Cortina Systems® LXT973 10/100 Mbps Dual-Port Fast Ethernet PHY Transceiver

Specification Update

20 March 2007

Revision 10.0

Item 9: Detection of Illegal Symbols After SSD

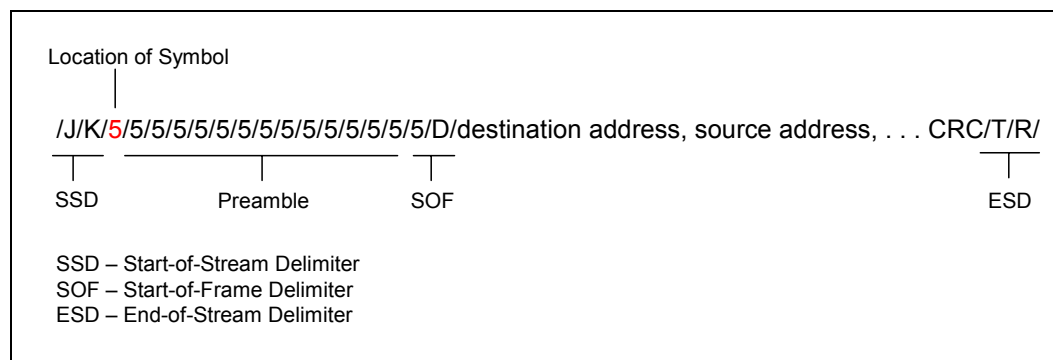
- Problem** An illegal symbol placed immediately after the Start-of-Stream Delimiter (SSD) (preamble after JK) is not detected. However, any subsequent corrupt symbol will be detected.

- Implication** RXER will not assert if this symbol location is corrupted. However, an error in this location does not affect packet integrity.
- Workaround** Use the MAC layer protocol to detect corrupt symbols in the packet.
- Status** There are no plans to fix this erratum.

Figure 4 **Ordering Information – Sample**

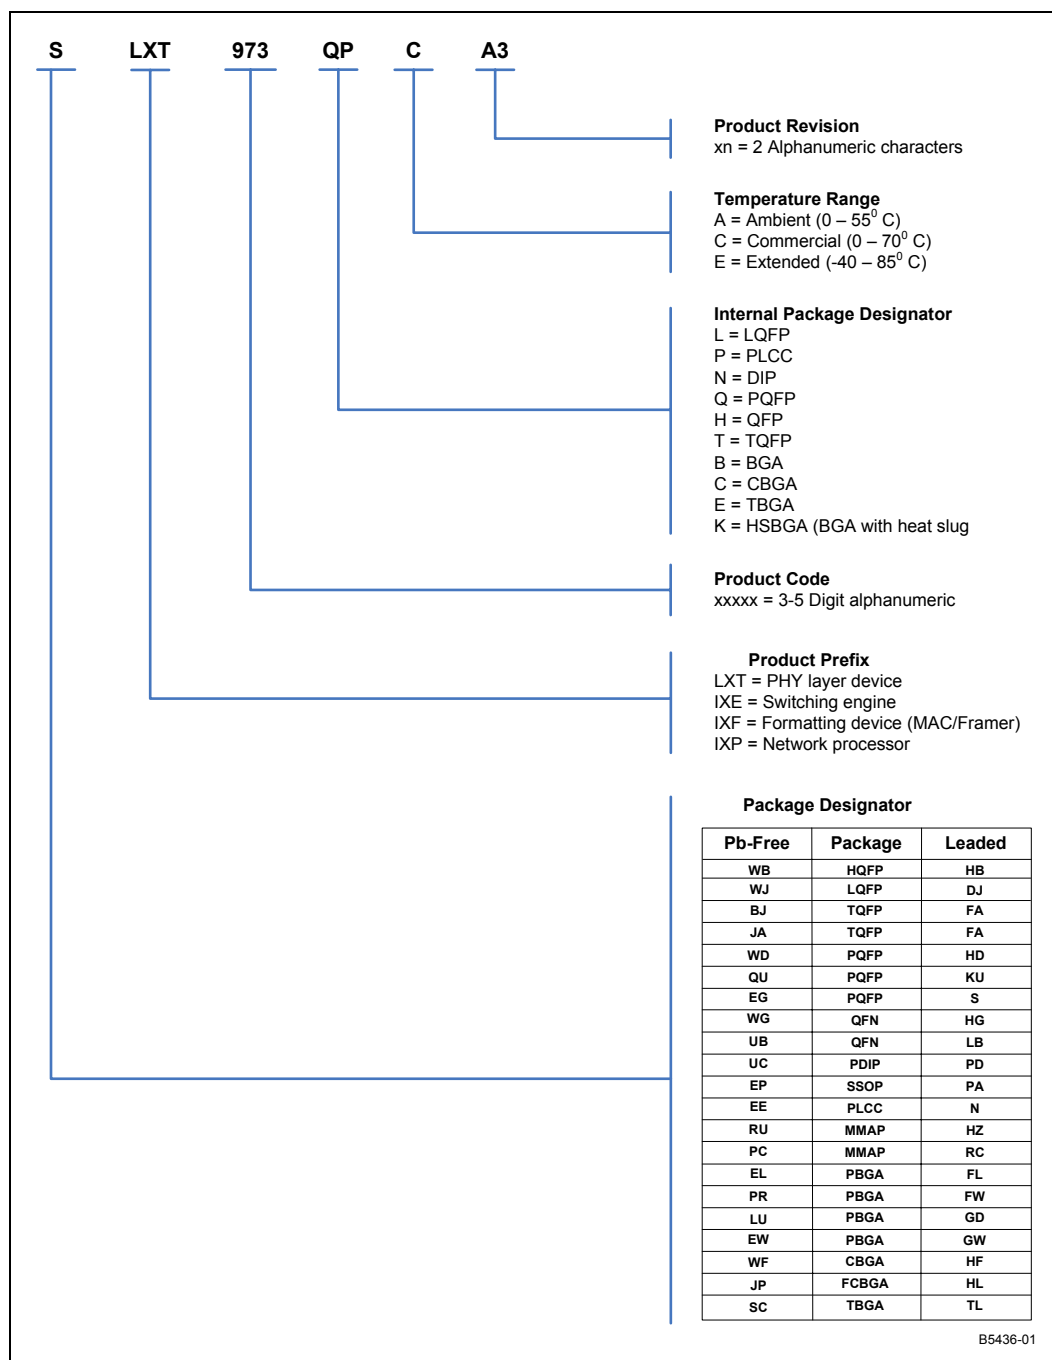
Item 1: Product Ordering Information

Table 3 lists the LXT973 PHY Transceiver product ordering information. Figure 4 provides the ordering information matrix.
